Lower Thames Crossing

Savills Note on CAH5 Oral Submissions

Quality management			
Prepared by:	Daniel Smyth	Director, Environment & Infrastructure	
Reviewed by:	Tom Dearing	Associate Director, Environment & Infrastructure	
Report ref:	LTC CAH5 Written Summary	Date of issue:	5 December 2023

Figure 1: Areas of Land that LTC has included that should have been discounted or avoided

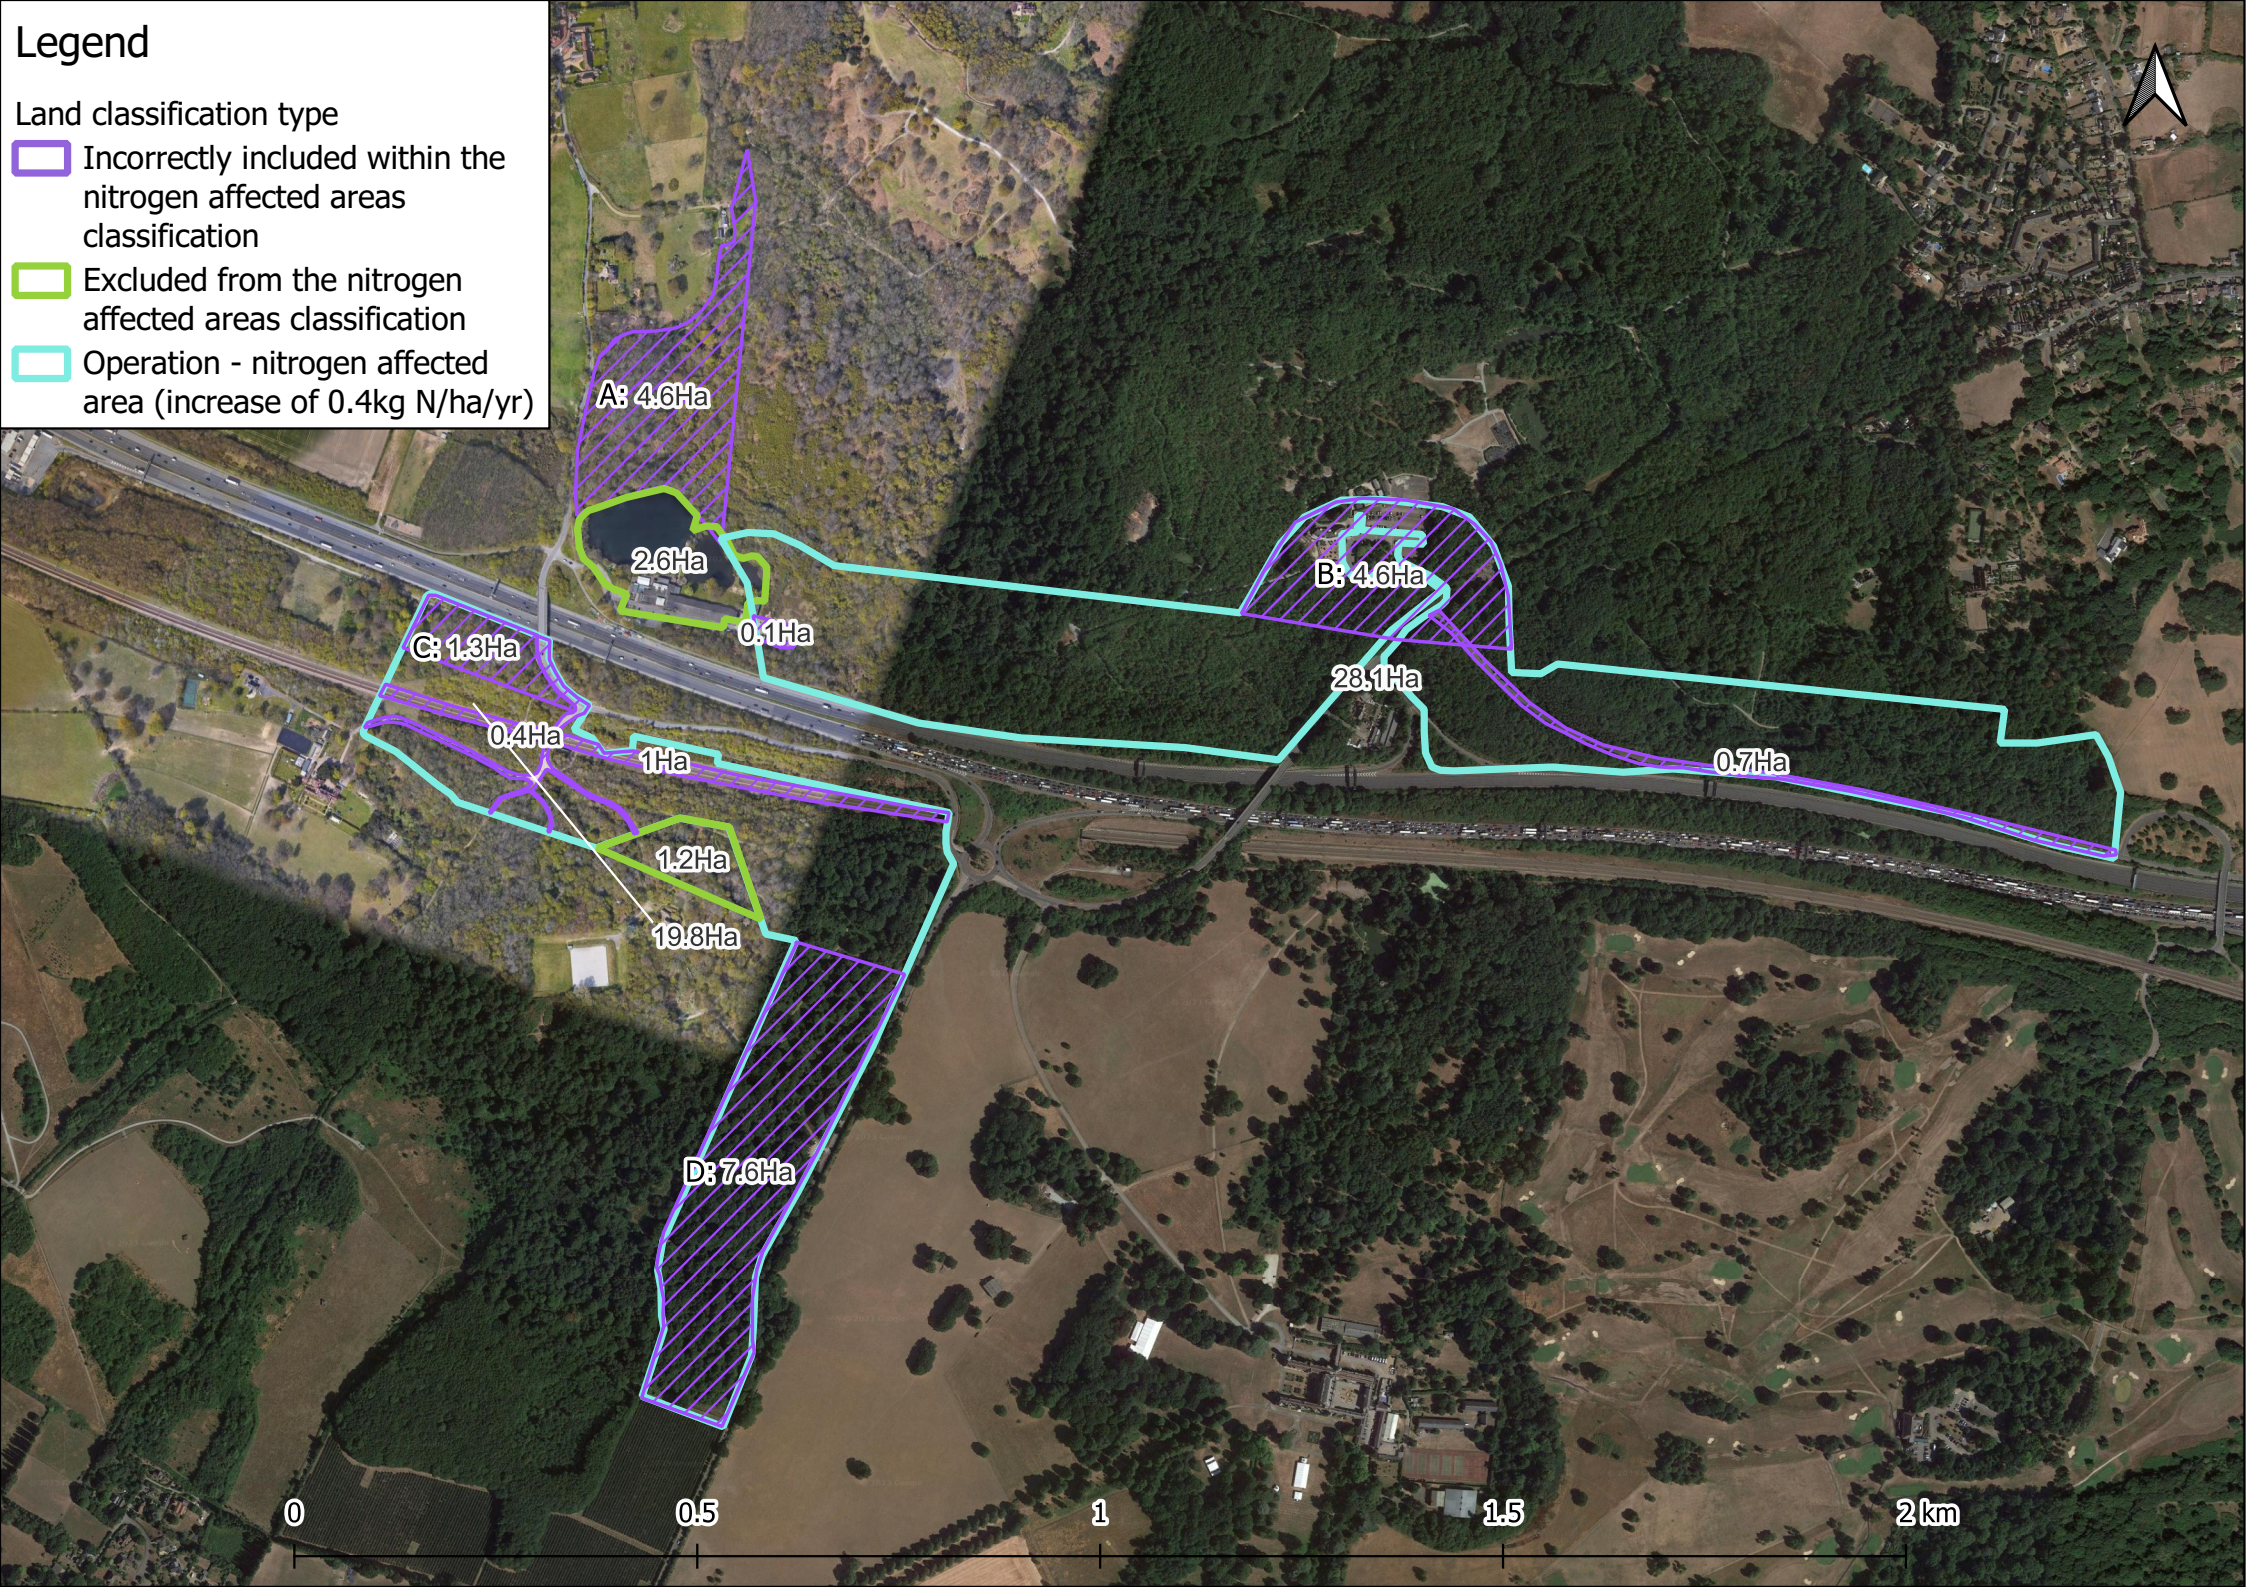
- 2.4.3 By reference to Figure 1 appended it is unclear what part of the highway network affects land parcel a of 4.6 hectares which is more than 200 metres away from the main route but it appears to be adversely affected by traffic increases along Thong Lane.

- 2.4.4 It is similarly unclear what part of the highway network affects land parcel B 4.6 hectares unless it is increases in traffic flows along Brewers Rd. This area excludes parts of Sean woods adventure centre but appears to include substantial areas of car parking, the visitor centre and café.

- 2.4.5 We think that Area C will be physically destroyed by new highway but has been included for the purposes of the nitrogen compensation calculations and that's double counting.

- 2.4.6 In terms of area D we are unclear why increases in traffic flows along Halfpence lane are allowed and lead to the whole of this area being affected.

- 2.5.3 It also seems that LTC treats areas of land that are not sensitive to Ndeposition as if they are: for example, the railway and areas of land that would be physically removed by the new highway. We have prepared a plan that illustrates this, which is attached as Figure 1.

Figure 2: SJC Alternative Design

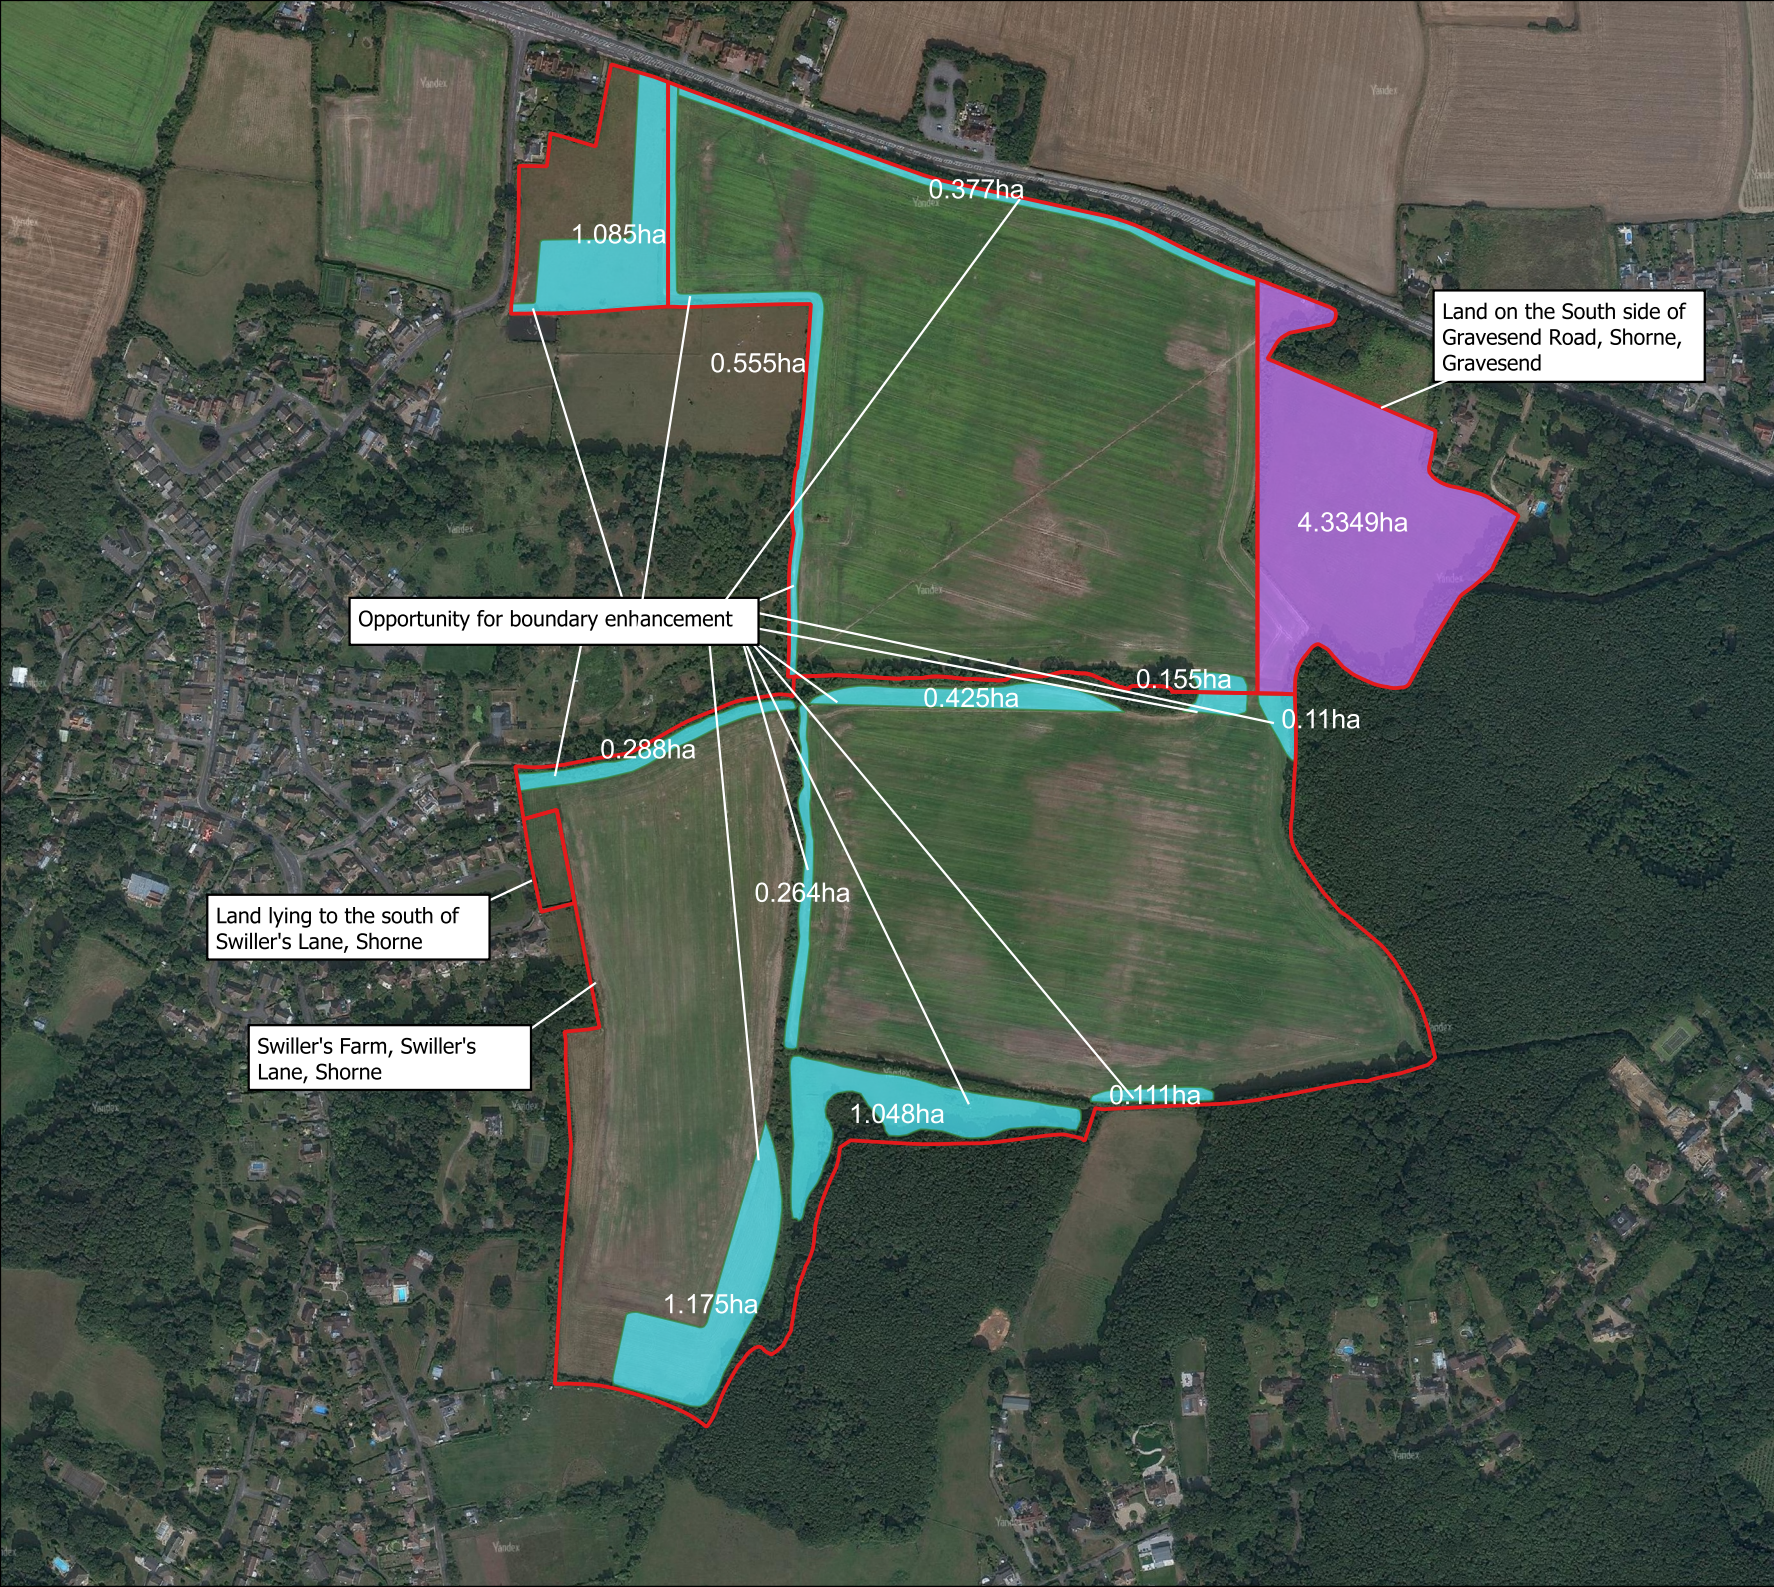
- 3.5.3 In essence, SJC's proposals are to plant, close gaps and strengthen hedgerows, provide regenerative field margins to improve biodiversity and habitat corridors, and to reduce artificial fertiliser inputs to this land through regenerative farming techniques. This will improve the soil structure and retain it for future generations, contributing to food security. Please refer to the Figure 2 appended.

Figure 3: SJC Alternative Sites

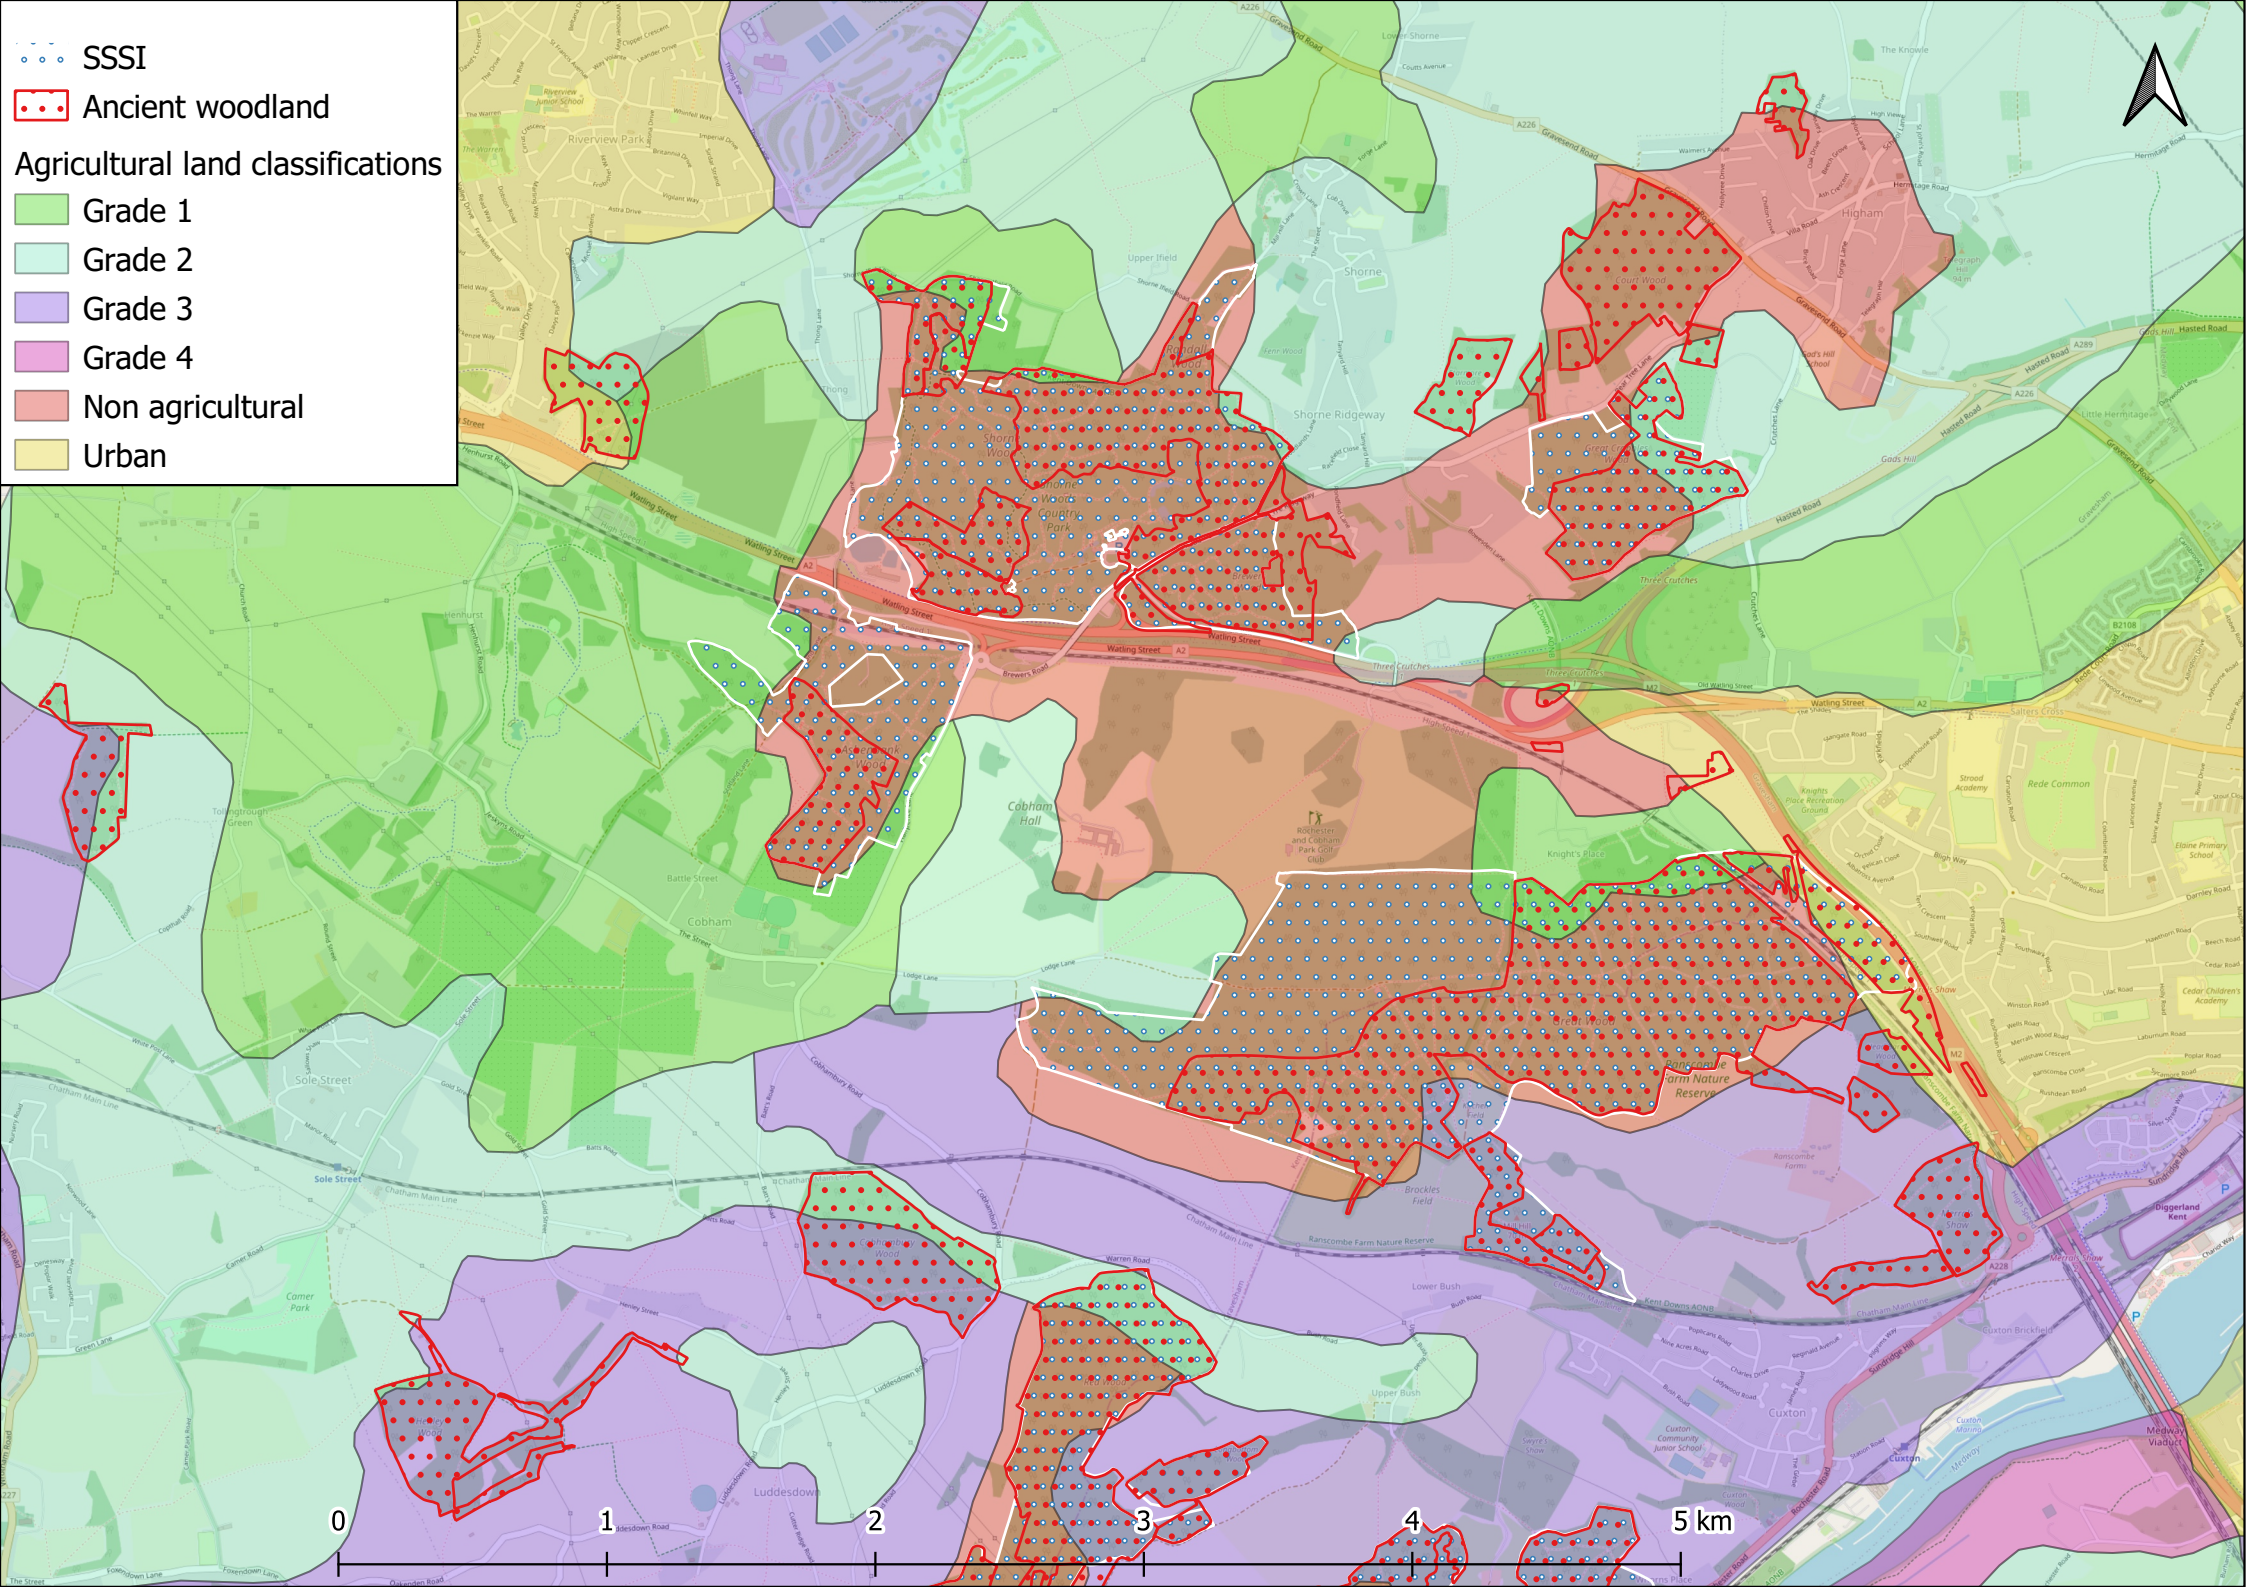
- 2.6.3 Inadequate consideration has also been given to the availability of suitable land further from the project, given the study area used by LTC. We attach a number of alternative land parcels that could have been considered as Figure 3.

- 3.5.2 This has been focused on land within SJC's ownership, although we note from aerial photography and local knowledge, that there are other smaller, less viable fields for agriculture, that look at least as suitable for these purposes in the surrounding area to both the north and the south of the route and we have prepared Figure 3 to demonstrate this.
